# NEWS FLASH!!!

## Upgrade your starter to Mitsubishi Electric!

### Effective January 4th, 2016:

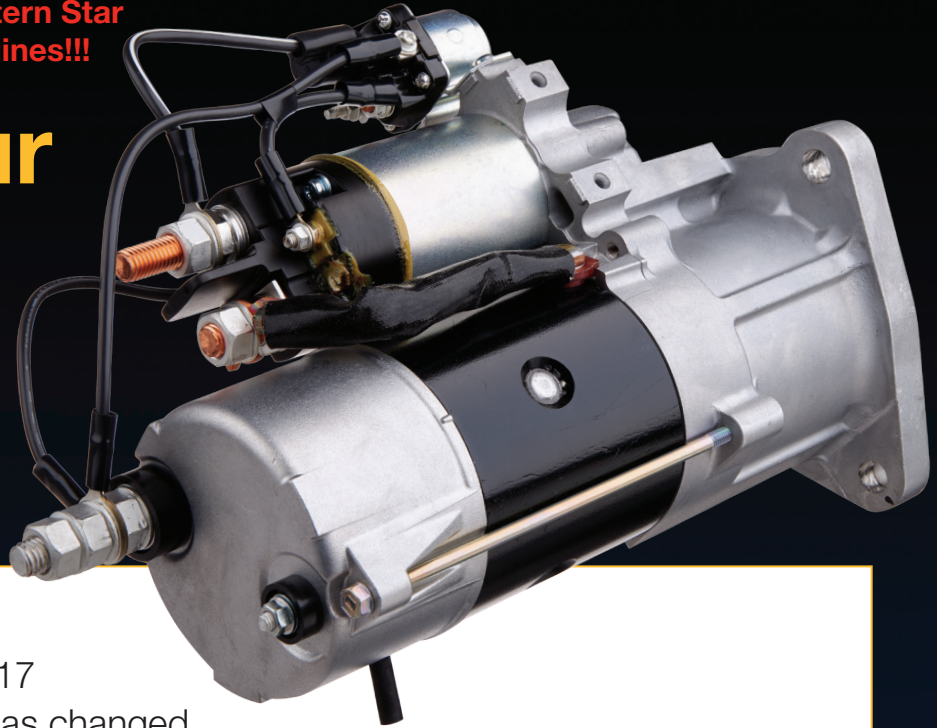
The number of teeth on the GHG17 Detroit Diesel 13/15/16 engines has changed. FL0189 can no longer be used with these new engines. The NEW Diamond Gard Part number for these GHG17 engines is FLA579.

For use on 2015 or older DD13/15/16 engines with 160 tooth ring gear ONLY – any other use will damage unit.

For use on 2016 or newer DD13/15/16 engines with 150 tooth ring gear ONLY – any other use will damage unit.
